Regular Meeting Agenda
Planning Commission

2. SR2020-0027/EA2020-0020: MONTEREY-MINER (JEMCOR)- DESIGN REVIEW PERMIT AND ENVIRONMENTAL ASSESSMENT FOR A 249-UNIT, MULTI-FAMILY AFFORDABLE RESIDENTIAL COMMUNITY. THE PROPERTY, IDENTIFIED BY ASSESSOR'S PARCEL NUMBER 726-36-059, IS LOCATED NORTH OF THE MONTEREY ROAD AND MADRONE PARKWAY INTERSECTION (JEMCOR DEVELOPMENT PARTNERS, OWNER).

PLANNING COMMISSION STAFF REPORT

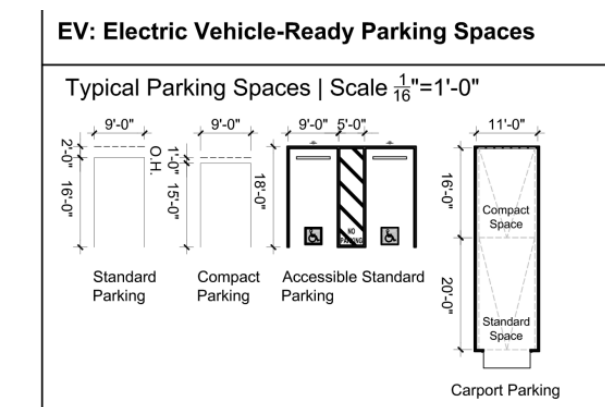
67. Inadequate interface analysis was given to adjacent SFD properties. While there is a step back of heights proposed along Taylor Avenue there is none proposed for the SFD properties on Ginger Way in Buildings 7, 9, 10 and 11 in site plan.

Planning Response: See response to No. 9.
